# UNITED STATES PATENT AND TRADEMARK OFFICE

APPLICATION NO.	FILING DATE	FIRST NAMED INVENTOR	ATTORNEY DOCKET NO.	CONFIRMATION NO.
10/505,302	05/09/2005	Alain Flers	003D.0030.U1(US)	6013

# Office Action Summary

**FIG. 4**

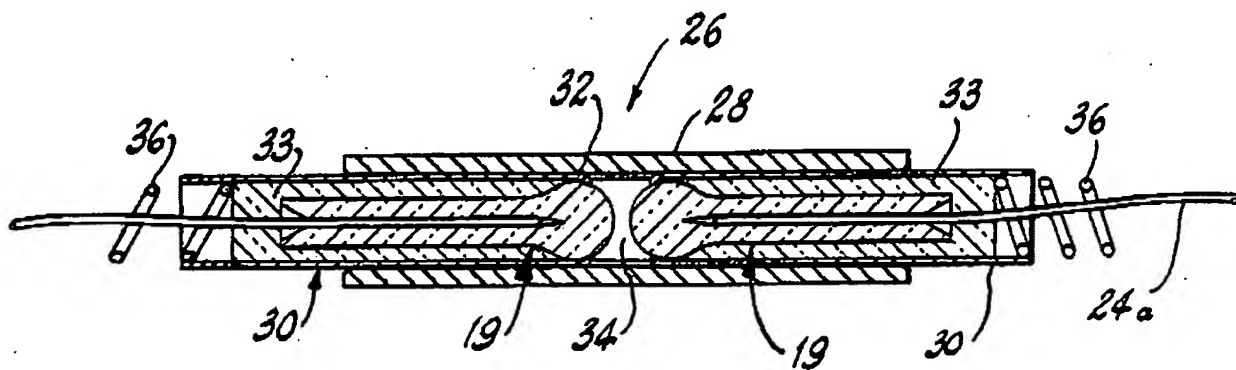
6. **Claims 1-4, 8, 9, and 11 are rejected under 35 U.S.C. 102(b) as being clearly anticipated by Patent No. 4,844,580 to Lynch et al. ("Lynch") previously made of record.** *In re* claims 1, 2, and 11, Lynch discloses a module package 26 comprising a housing 28/30/33 and having an optical waveguide section 18/19/24a interposed between an input optical port of the module and an output optical port of the module, wherein said optical waveguide section comprises at least one flared cone 19 enlarged at one end of the waveguide section and forming an optical input section, and further comprising an end lens 18, wherein the optical section 18/19/24a comprises a portion 19/24a having a diameter which smaller than a diameter of the flared cone along a length of the housing. Figure 4 of Lynch is reproduced below.

Applicant is advised that the method of forming a device is not germane to the issue of

patentability of the device itself. Thus, the "overmolded" and "overmolding" limitations recited by claims 1, 2, and 11 have not been given patentable weight since overmolding is considered a method of forming the device and does not differentiate the structure of the device itself.
